DEVELOPMENT REVIEW COMMITTEE (DRC) COMMENT REPORT

PROJECT NAME: 1515 Cluster

CASE NUMBER: R18005

REQUEST: Site Plan Level III Review: 12 Unit Residential Cluster Development

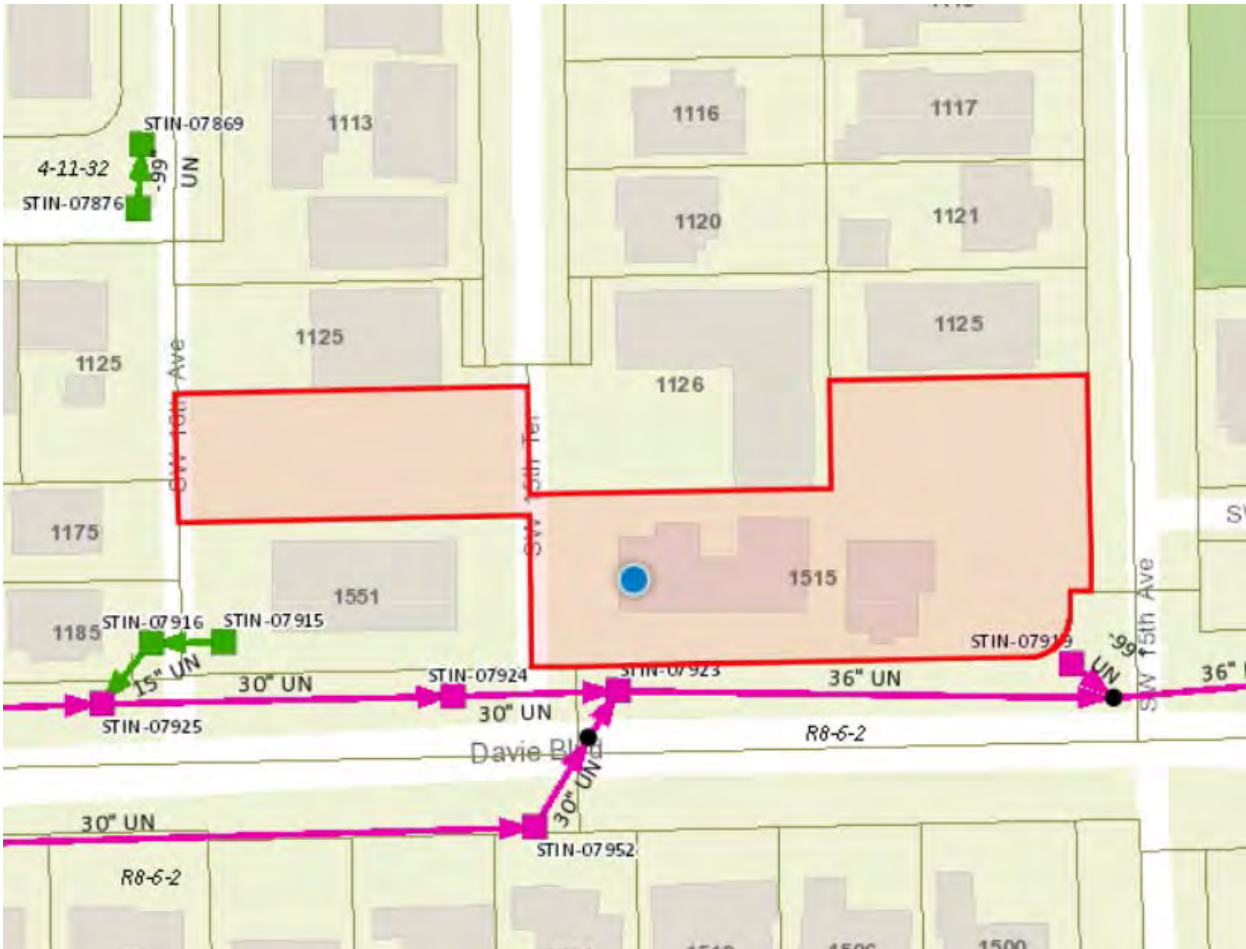
The City owns and maintains stormwater infrastructure adjacent to the proposed development as shown with green line work in the map provided at the end of this report. The following comments pertain to possible impacts of the proposed development and/or construction activities to the existing condition of the City's stormwater assets, including street swales. The applicant shall provide an itemized response letter addressing the following comments:

- a) Contractor shall provide CCTV videotapes to City STW OPS of the existing stormwater system to the limits shown with green line work in the storm map provided at the end of this report in order to document the PRE and POST construction conditions of the City's storm system.
